TO: Service Locations

FROM: Service Systems Development

SUBJECT: **DD Heavy Duty Platform Belt Tensioner Change**

**Fig. 2, New Friction Damping Tensioner**

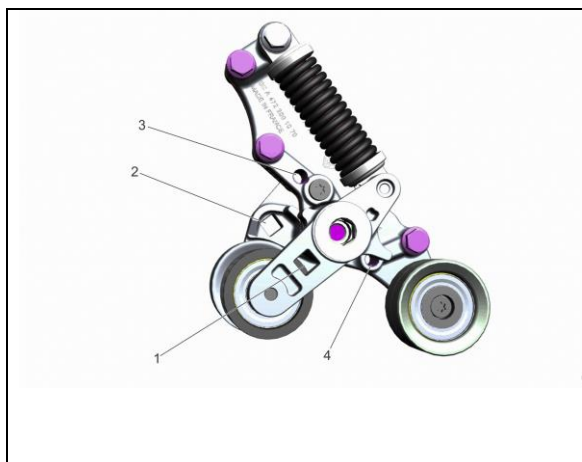
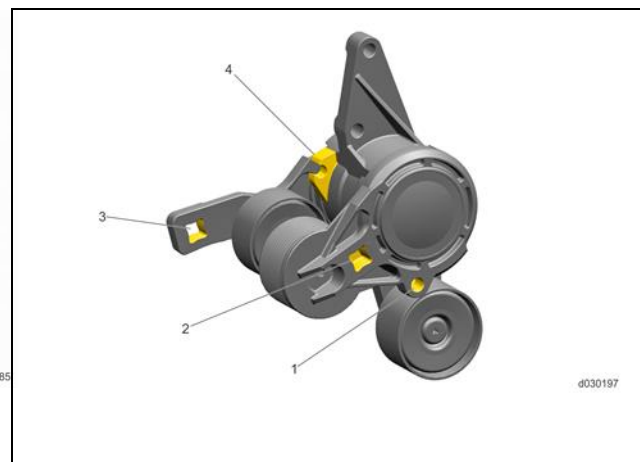
A newly designed, dual-arm friction shoe damping tensioner was implemented for the DD Heavy Duty Platform. New tensioner P/N: A4722001370 was released to engine production on December 7th, 2018, with approximate engine serial number HDE0644305 for current USA/Canada and export engines. Belt lengths and maintenance interval per application and engine variance did NOT change. For current belt information, reference Technical Service letter 18 TS-4rev. New sections in the appropriate workshop and troubleshooting manuals have been created. The new sections are labeled “Friction Belt Tensioner”. The tensioner should only be replaced if indicated by the appropriate troubleshooting manual procedure.

**The new friction damping tensioner is not backwards-compatible with certain vehicles built before November 1, 2017.** The new tensioner can be used in all vehicles built on or after November 1, 2017. Certain vehicles built before November 1, 2017 will use a different aftermarket friction damping tensioner, part number GT 38667. Refer to Chart 1 for part numbers.

**Note:** The new friction damping tensioner, P/N A4722001370 and the aftermarket tensioner, P/N GT 38667 are not interchangeable. Tensioner GT 38667 should not be used on vehicles built after November 1, 2017.

**Selecting the incorrect tensioner may prevent proper installation due to interference between the tensioner and the fan clutch. This interference may be difficult to identify visually.**

**Fig. 9, Friction Damping Tensioner Enhancement Description**

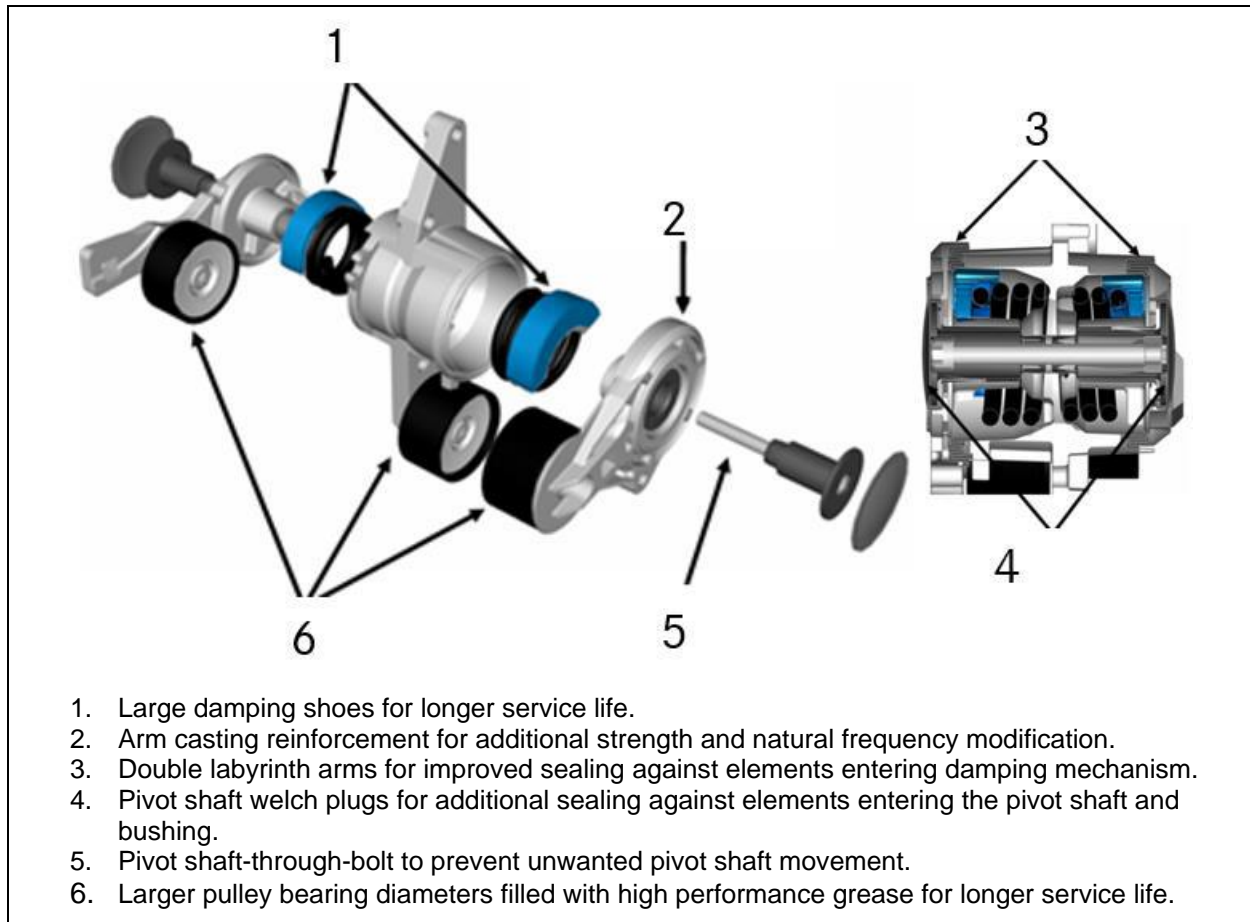
Detroit™ recommends using the new friction damping tensioner, **when applicable and according to Chart 1**. The new belt tensioner has been through vigorous testing to optimize functionality and reliability. The following components have been optimized for the new friction damping tensioner.
